DEVIATION REQUEST AND DECISION FORM

Project Name :	Grandview Reserve
Schedule No.(s) :	
Legal Description :	<p>A TRACT OF LAND BEING PORTIONS OF THE SOUTH HALF OF SECTION 21, SOUTH HALF OF SECTION 22, NORTH HALF OF SECTION 28 AND SECTION 27, TOWNSHIP 12 SOUTH, RANGE 64 WEST OF THE SIXTH PRINCIPAL MERIDIAN, EL PASO COUNTY, COLORADO, BEING DESCRIBED AS FOLLOWS:</p> <p>BASIS OF BEARINGS: THE EAST LINE OF SECTION 21, BEING MONUMENTED AT THE SOUTHEAST CORNER BY A 3-1/4" ALUMINUM SURVEYOR'S CAP STAMPED "PS INC PLS 30087 1996", BEING APPROPRIATELY MARKED, AND BEING MONUMENTED AT THE NORTHEAST CORNER BY A 3-1/4" ALUMINUM SURVEYOR'S CAP STAMPED "PS INC PLS 30087 1996", BEING APPROPRIATELY MARKED, BEING ASSUMED TO BEAR NORTH 00 DEGREES 52 MINUTES 26 SECONDS WEST, A DISTANCE OF 5290.17 FEET.</p> <p>COMMENCING AT THE SOUTHEAST CORNER OF SAID SECTION 21; THENCE NORTH 00 DEGREES 52 MINUTES 26 SECONDS WEST ON THE EAST LINE OF SAID SECTION, A DISTANCE OF 2645.09 FEET TO THE NORTHEAST CORNER OF THE SOUTHEAST QUARTER OF SAID SECTION 21, SAID POINT BEING THE POINT OF BEGINNING; THENCE NORTH 89 DEGREES 41 MINUTES 03 SECONDS EAST ON THE NORTH LINE OF THE SOUTH HALF OF SAID SECTION 22, A DISTANCE OF 39

Figure 1- Proposed Cross Section for MST

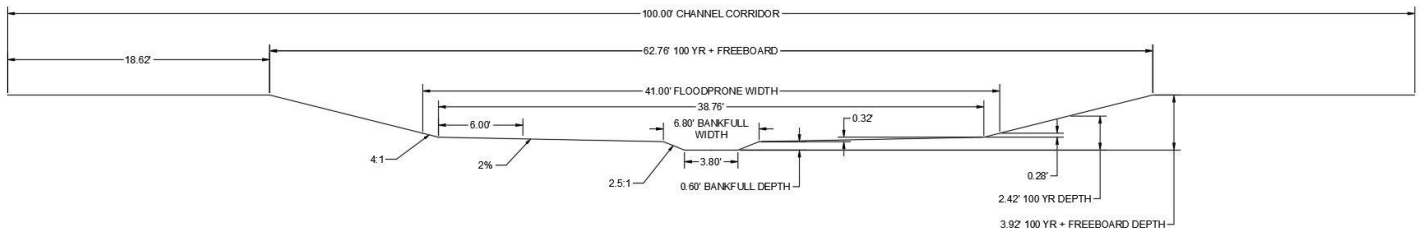
It is proposed to shift the existing channel away from its current alignment to facility the proposed land plan. The channel shift would allow for a 100-foot corridor to be dedicated to the channel and maintenance access. Initial modeling and calculations indicate the channel width at the 100-year water surface elevation + freeboard will need to be 62.76' wide. The additional ~40' width to the overall corridor will allow for maintenance access and for significant room to allow for flexibility in the naturalized channel design approach. Within the 62.76' valley the low flow channel is to meander in a fashion similar to what would be expected in an unaltered, stable reach based on the geomorphology of the project site.

Section 10.5.3 Bottom Width: It is requested that a bottom width of 3.8 feet and a bankfull width of 6.8 feet be permitted to facilitate a design that accounts for the wide range of expected flows through the stretch of channel being designed. This design variance is based upon guidance given in MHFD’s DCM volume 1 table 8-2. Based on a design flow depth of ~ 0.5 feet, it is recommended a minimum bankfull channel width of 6 feet be targeted. Through an iterative analysis it was determine that a cross sectional geometry with a bottom with of 3.8 ft, bankfull width of 6.8 feet would result in a flow depth of 0.6 feet for 70% of the 2-year event.

Section 10.5.4 Low Flow Channels: It is requested that a low flow channel with a capacity of approximately 70% of the 2-year flow be permitted. We prefer to use 70% of the 2-year event as the effective discharge channel as it approximately correlates with the 1.5-year flow interval. It is generally believed that the 1.5-year flow is the effective discharge forming flow for this region. MHFD currently states to use the greater of the two values as stated below, but recent conversations have indicated that the design consideration is based on the geographic location of the channel and soil conditions.
